Planning Commission Vote Report

Petition: P.Z. 09-2017 18385 Chesterfield Airport Rd. (Chesterfield Hockey Association): A

Responses to City Comment Letter dated 6/20/28

CHESTERFIELD ICE AND SPORTS COMPLEX AND FUTURE DEVELOPMENT PRELIMINARY PLAN

SITE SECTION C-C SCALE: 1'-50'

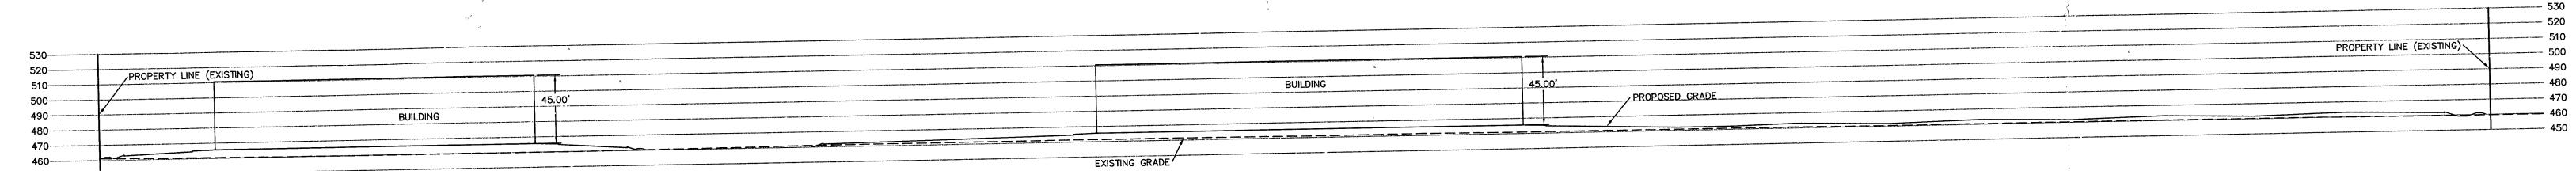
<u>Comment 9.</u> Site Section C-C on page C-1 shows two property lines as proposed. Should a lot split or boundary adjustment process be necessary, it is a separate process and should be excluded from these plans.

Response: Completed.

TYPICAL SECTION OLIVE STREET ROAD EXTENSION - ULTIMATE

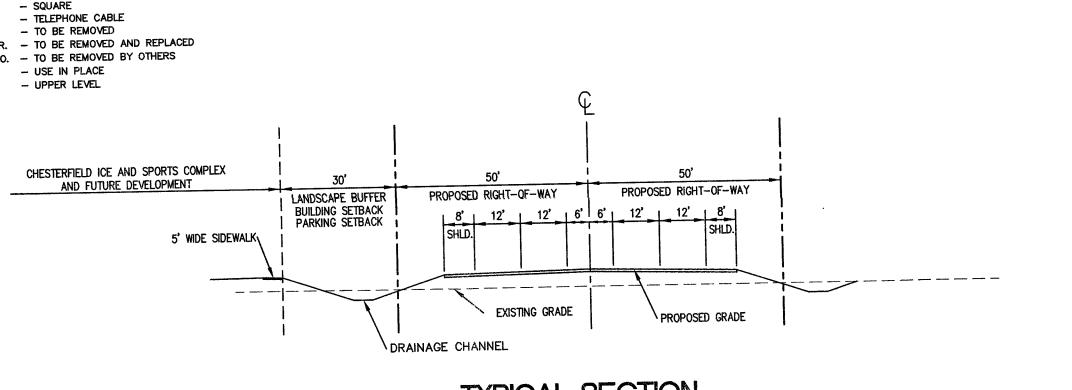
Comment 14. Provide a typical cross section of Olive Street Road.

Response: Completed.
